Approval no: DEV2024/1586

Statement of Advice

Aura Town Centre – Stage 1

Response to EDQ Further Issues – Traffic Matters

5. Internal Roads

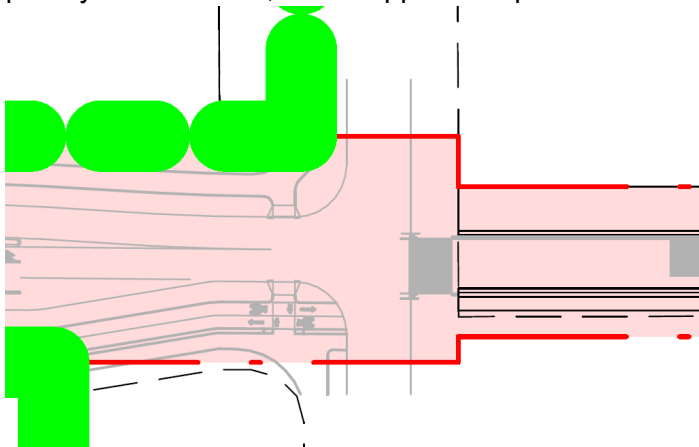
Submit updated drawings to demonstrate how the full extent of internal road works and the interim intersection arrangement at the below location can be consistent with a safer ultimate intersection (consider a roundabout or staggered priority intersections as per previous approval). The full extent of internal roads required as part of this stage of development have not been shown on drawings. In particular, the western road link to intersection 8 has been augmented, where previously it included 1-way roads and 3-way priority intersections, it now appears to promote an ultimate 4-way priority intersection:

- The amended architectural plans provided at **Appendix B** more clearly illustrate how this intersection will be staged by depicting the interim arrangement only to avoid confusion. That is, intersection approaches to the north and south will not be delivered as part of the Stage 1 development and would, therefore, result in an east-west road link only being delivered.

- The northern approach of the intersection will be provided in the future to facilitate a ramp connection to an extended basement car park. The extended basement car park will, in turn, facilitate east-west connectivity at the basement level, therefore removing the need for the interim circulation road east of this intersection and allowing the eastern approach to be converted to the "Western Pedestrian Link" and "Eastern Pedestrian Link".

- As a result, when the northern approach is provided at the subject intersection, the eastern approach will be able to be closed; thus, the intersection will not include more than three approaches concurrently.

- The provision of the southern approach would occur as and when required to support development to the south.

7. Main Street

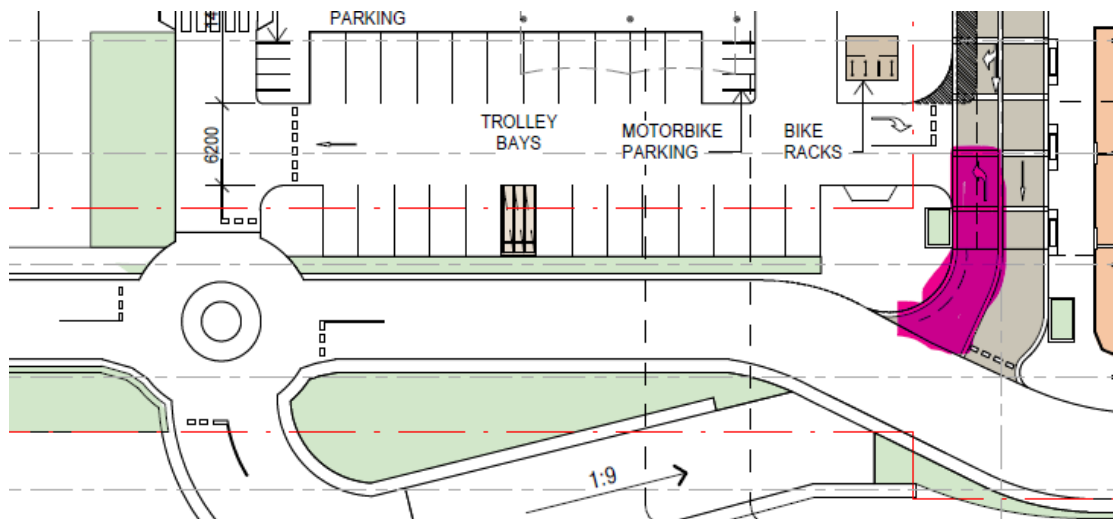
- Widen the bend in the northern section of Main Street to comply with AS2890.1 Off-street parking standards, ensuring unobstructed two-way operation.
- Amend Architectural plans updated with Main Street parallel parking bay dimensions in accordance with AS2890.1 requirements.

- SLR has reviewed AS2890.1 Section 2.5.2 and followed the methodology for determining a suitable width for the bend on Main Street towards the northern end.

- The current design of Main Street at this bend comprises a width of 7.3m and an outside radius of 11.8m. Table 2.2 shows no minimum roadway width for two-way circulation roadways with an outside radius between 7.6m and 11.9m.
- In lieu of this, SLR has undertaken a swept path assessment simulating two B99 vehicles travelling opposed to one another through this bend. This assessment demonstrates that this bend will accommodate two-way operation when Main Street is converted into its ultimate arrangement. A swept path sketch is provided at **Appendix D** for reference.

- The parallel parking spaces along the eastern side of Main Street achieve the dimensions specified by AS2890.1 Figure 2.5. That is, the spaces are 6.3m and 6.6m long with a 3.0m wide adjacent lane.
- To aid confirmation of this, the amended architectural plans at **Appendix B** now include annotated dimensions.

Drawing Number
A-DA-1000

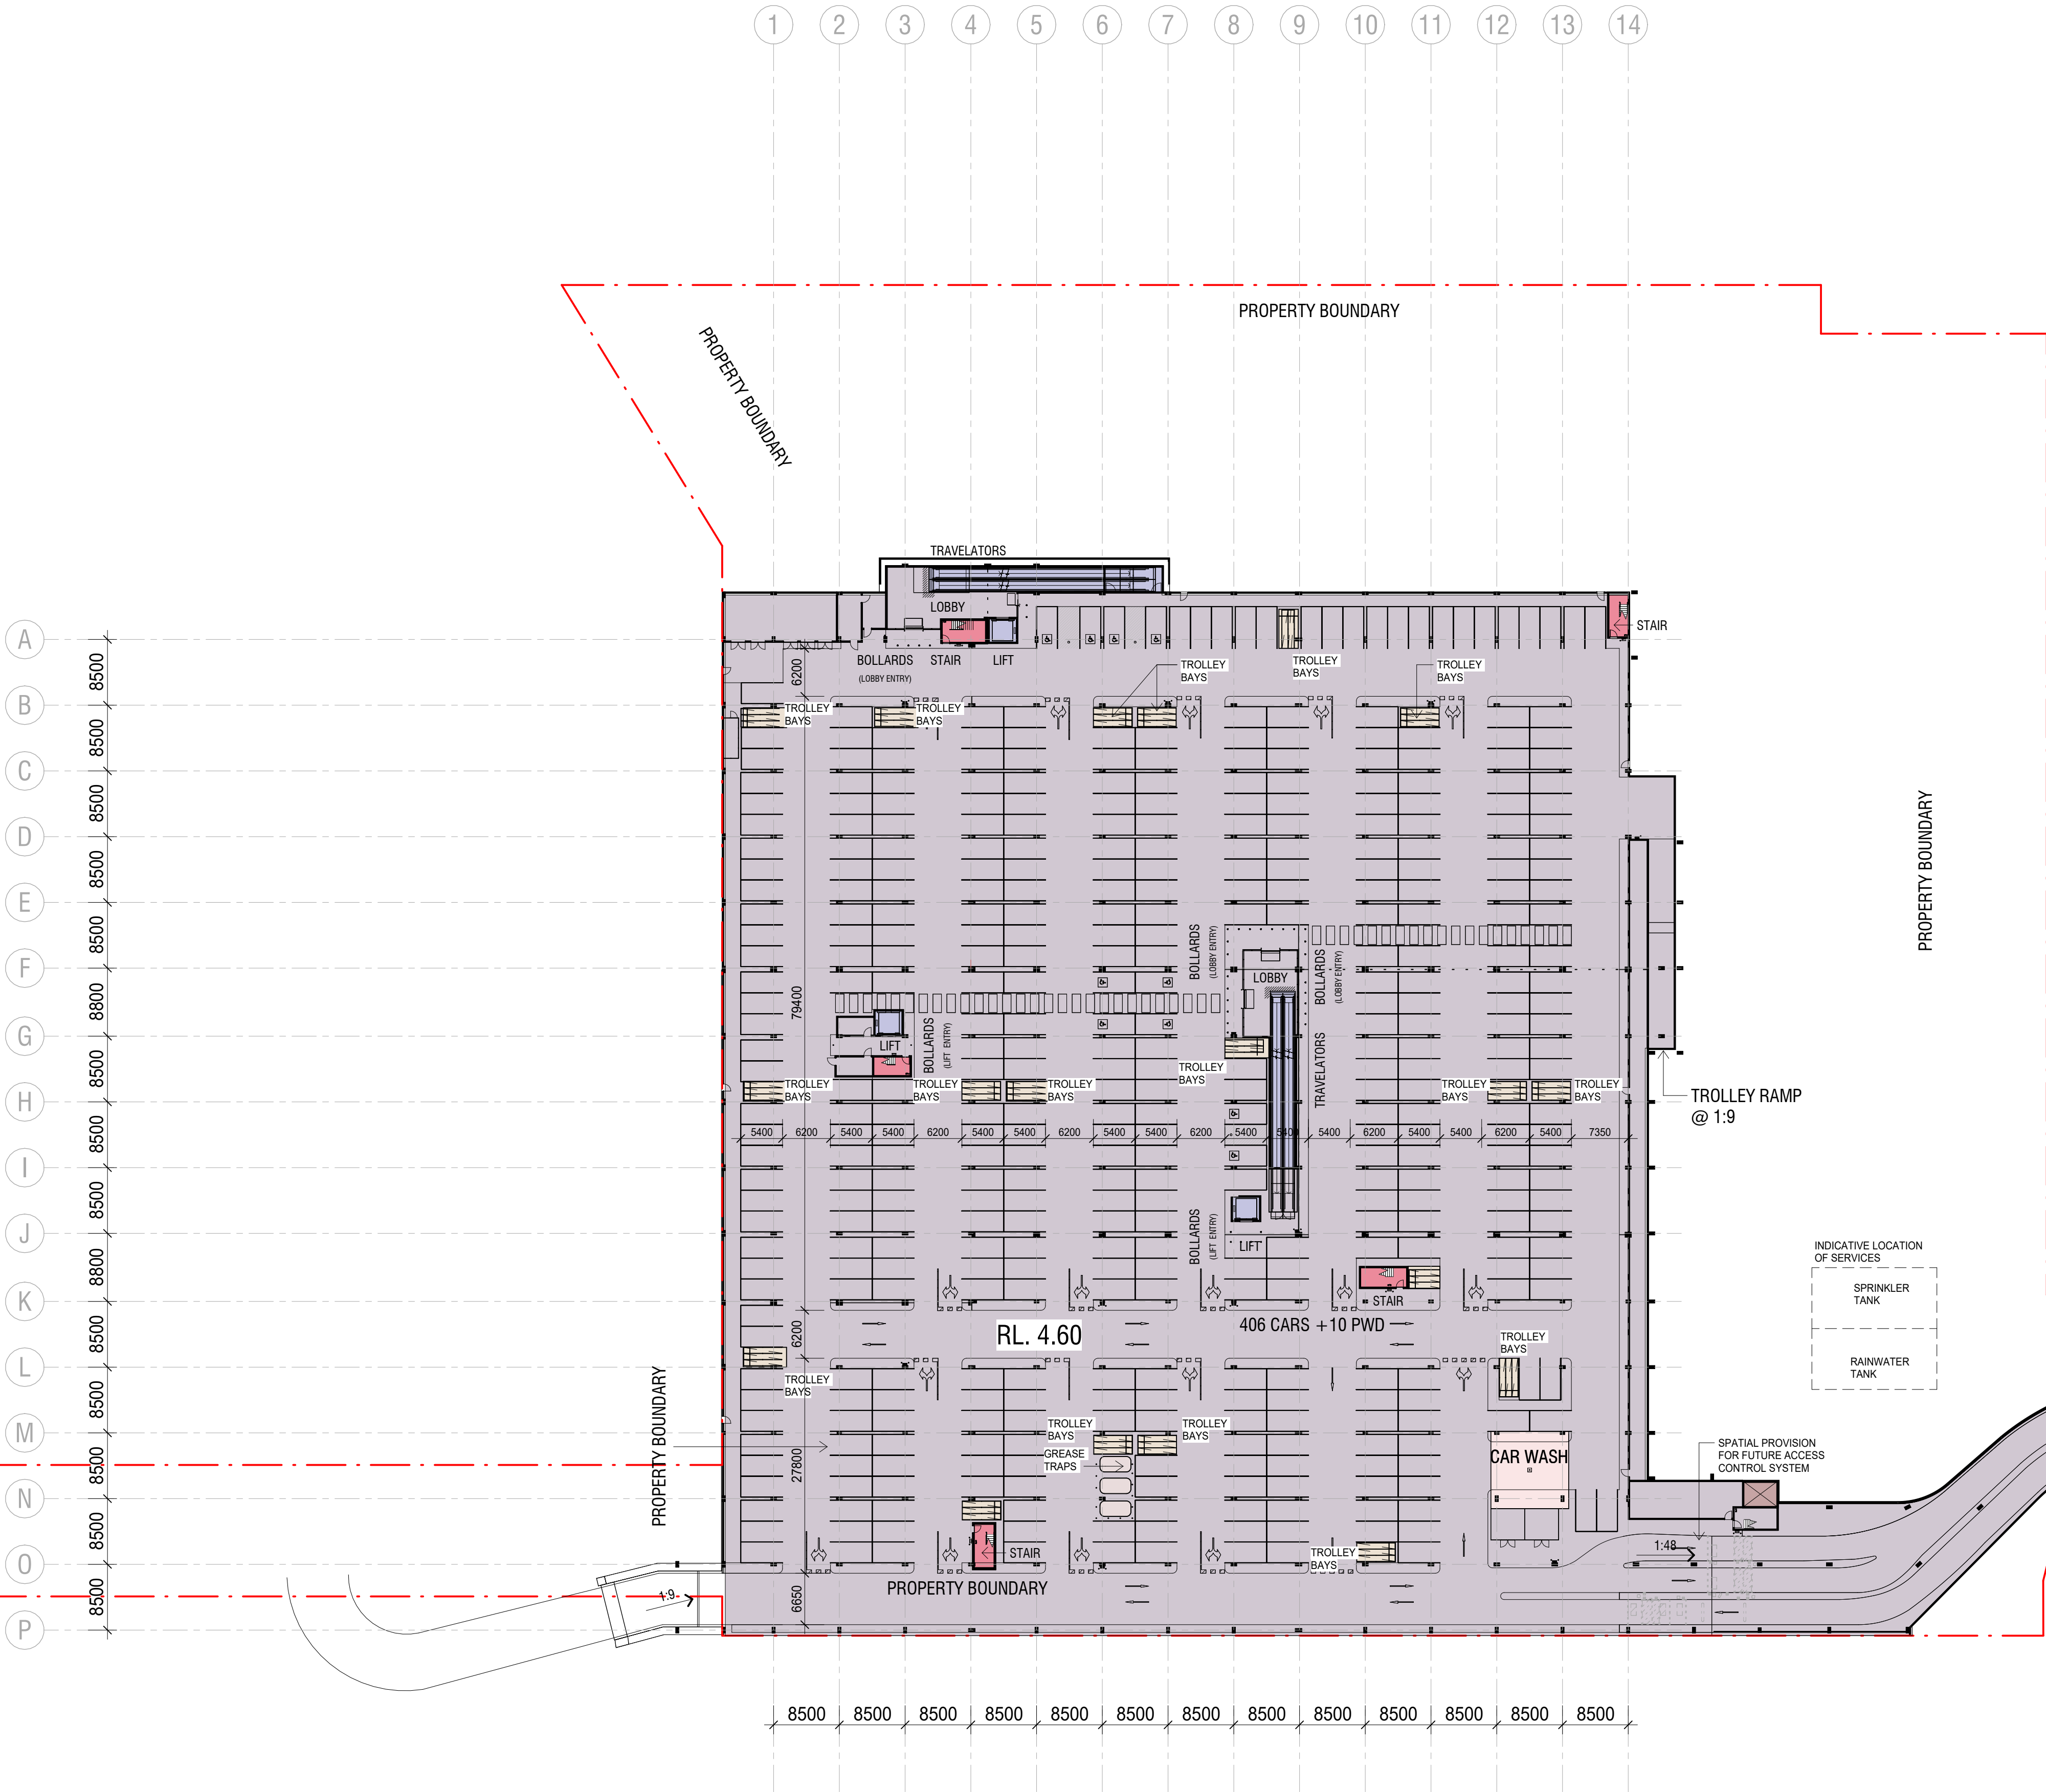
(a) Wheel stops where parking bays are adjacent to pedestrian circulation paths.

(b) Ensure there is sufficient space for a B99 vehicle to manoeuvre around the left turn exit from the south-eastern aisle (next to the carwash) without interference from the central median.

(c) PWD access (pedestrian) from the shared zone for the PWD spaces north of the 'Carpark Exhaust' are obstructed. Suggest swapping with the bays to the south of the exhaust."

- The Plan of Development (Table 23 DS4.5) requires that the car parks are designed in accordance with the AS2890 suite.
- In relation to wheel stops, AS2890.1 Section 2.4.5.4 Wheel Stops identifies that:

- Further to the guidance in AS2890, it is Stockland's operational experience from operating numerous centres over many years that the use of wheel stops should be avoided as wheel stops present a trip hazard for pedestrians, with this risk typically greater than the hazard the use of wheel stops minimises. As a result, Stockland's centre design guideline preferences the use of bollards where deemed necessary.

- Based on both the guidance presented in the relevant Australian Standard and Stockland's operational experience as captured within their internal design guideline, bollards have been selectively introduced into the amended design at **Appendix B**.

- It is noted that during detailed design, the precise location of each individual bollard indicatively indicated on the plans will be optimised. For instance, an intent has been shown on the drawings to install bollards along the pedestrian connection extending to the west from the southern mall entrance. The diagrammatic location of the bollard line unnecessarily constrains the width of the pathway; however, in practice, the location of each bollard will be optimised during the detailed design process as is typical.

- The amended plans provided at **Appendix B** address this item by converting the subject parking aisle to one-way.

- The amended plans provided at **Appendix B** address this item.

Appendix C Main Street Treatment

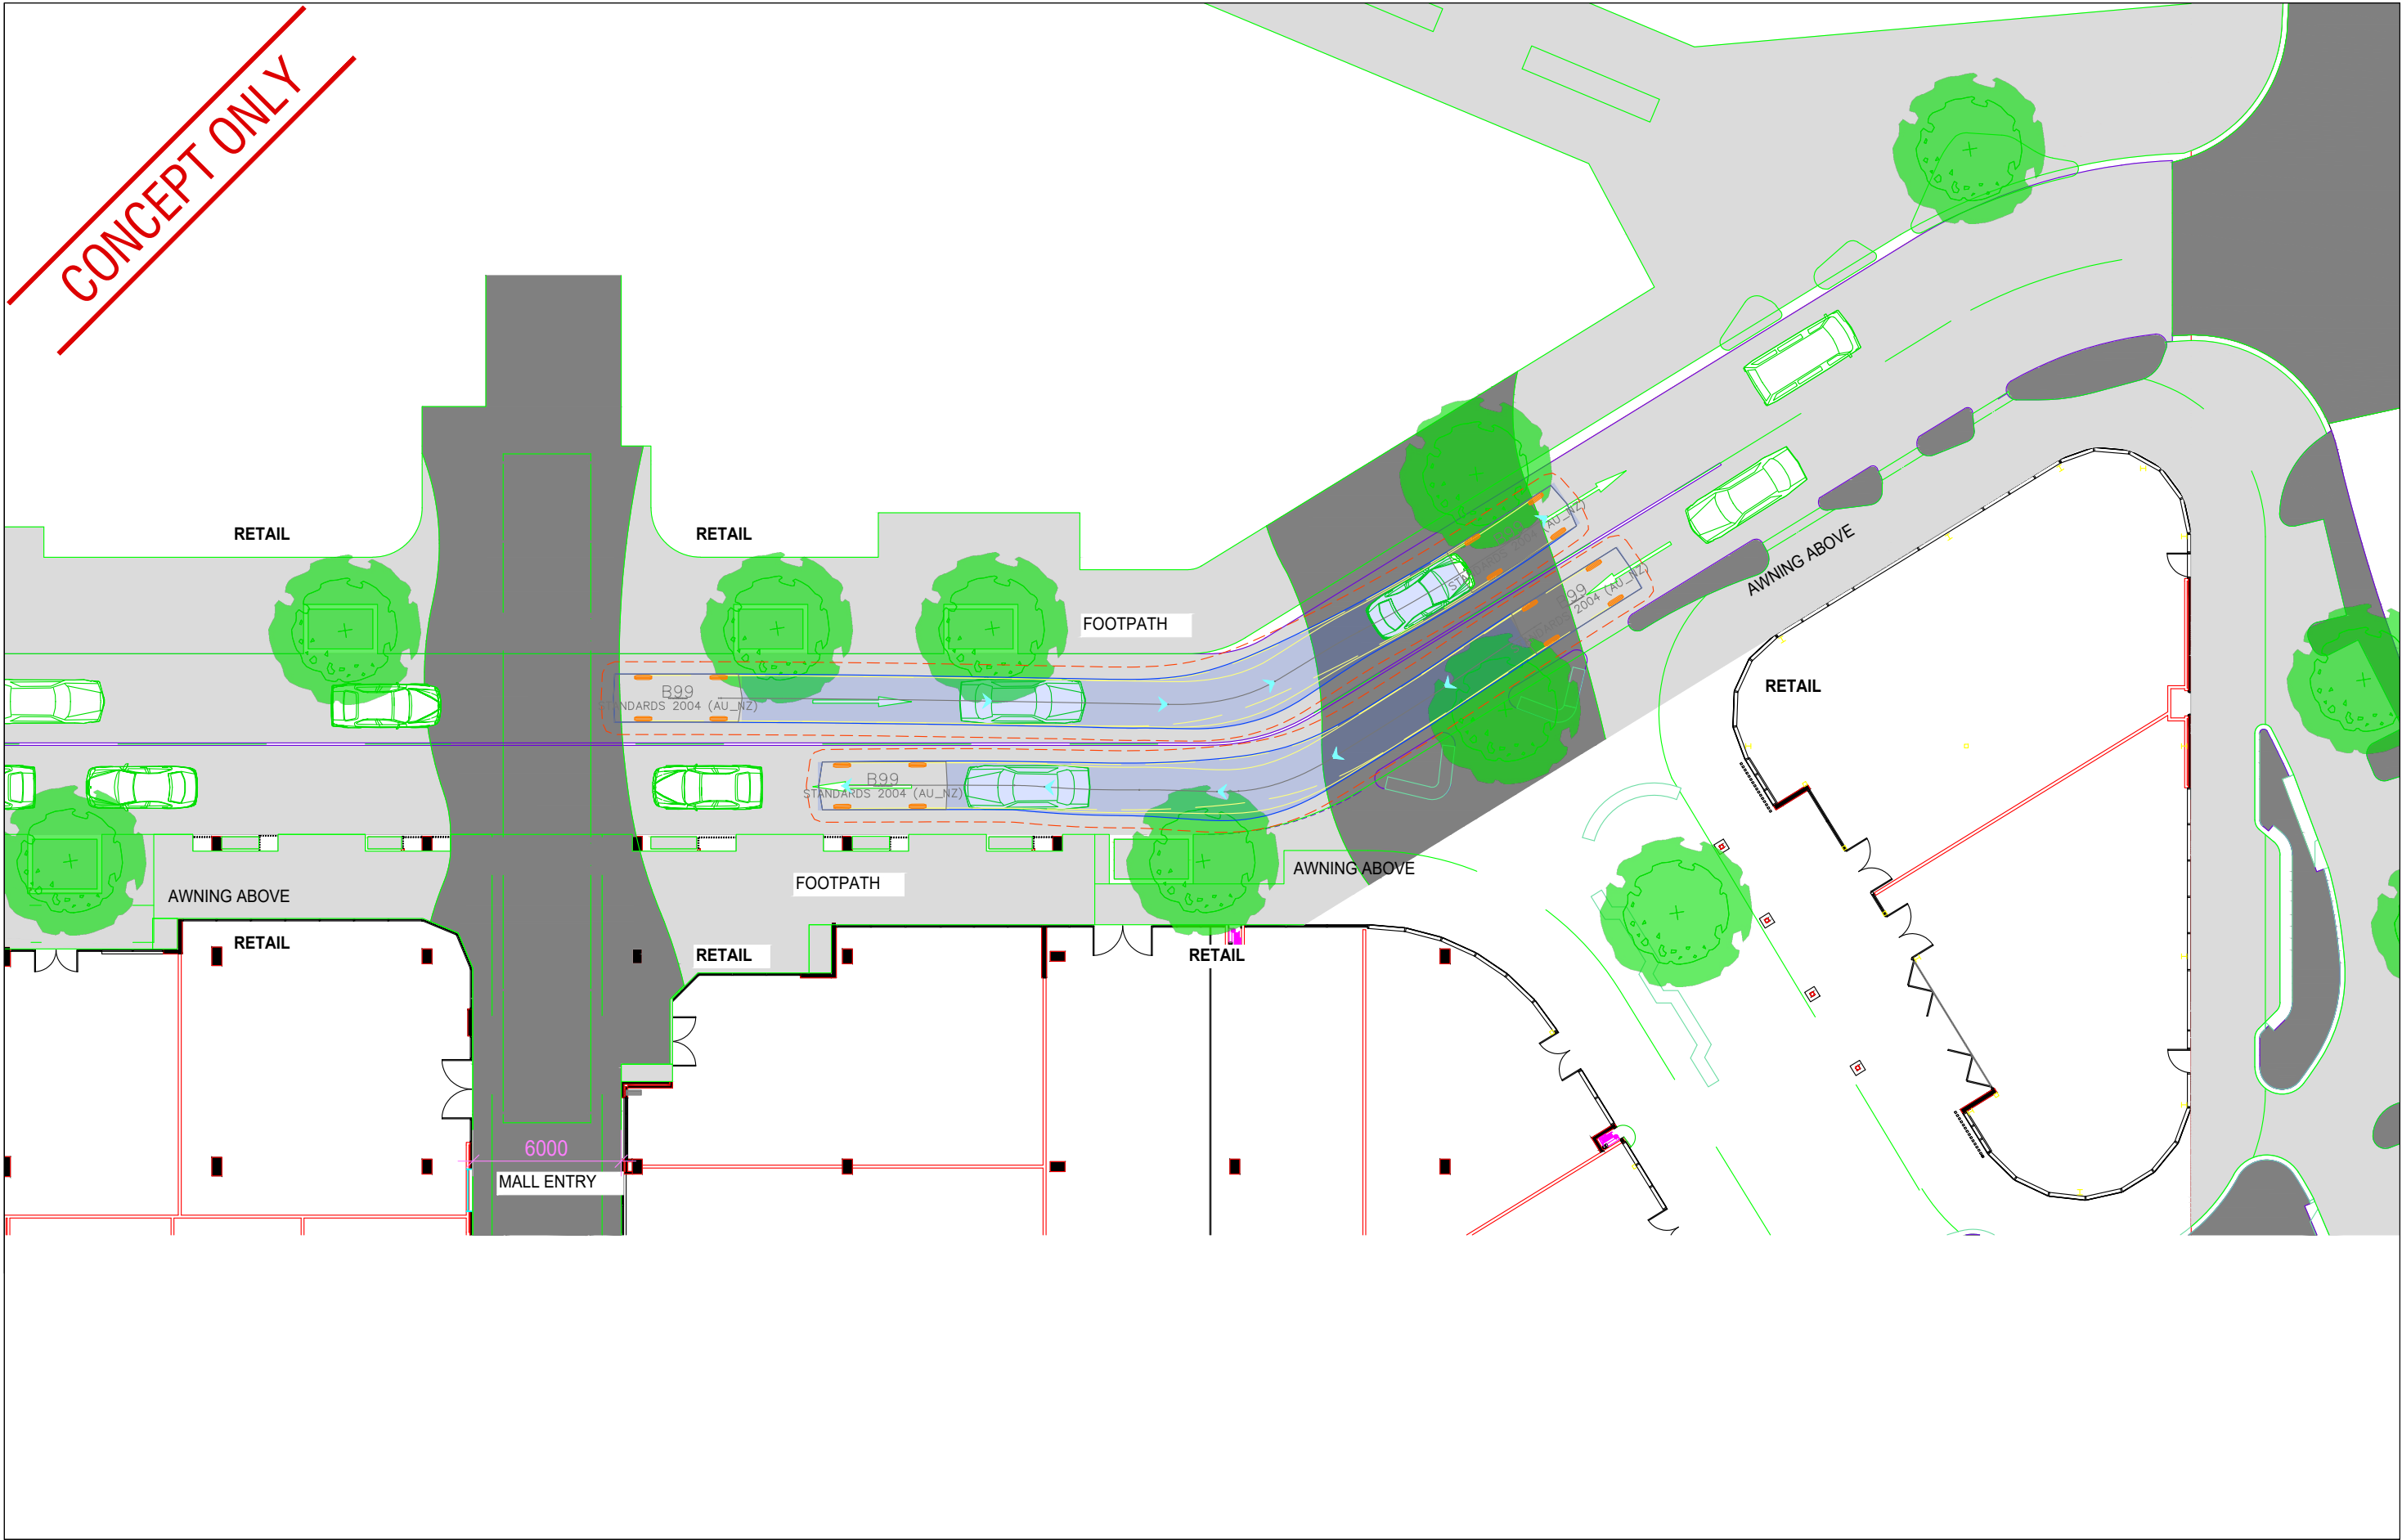
The architectural drawings must be updated to clearly show the 1.5m northbound bike lane and the shared southbound car lane, as outlined in the traffic report. Layout and cross-section drawings are to be amended accordingly. Additionally, linemarking, signage, pavement painting, and street works must be detailed to demonstrate how the shared environment will be established for both the interim and ultimate shared zone.”

- The amended architectural plans provided at **Appendix B** depict the 1.8m northbound cycle lane and how it will be delineated effectively from the southbound vehicle travel lane. In addition, **Appendix C** provides further details regarding the intent for signage, linemarking and pavement markings to manage conflict points and enhance wayfinding for cyclists safely.
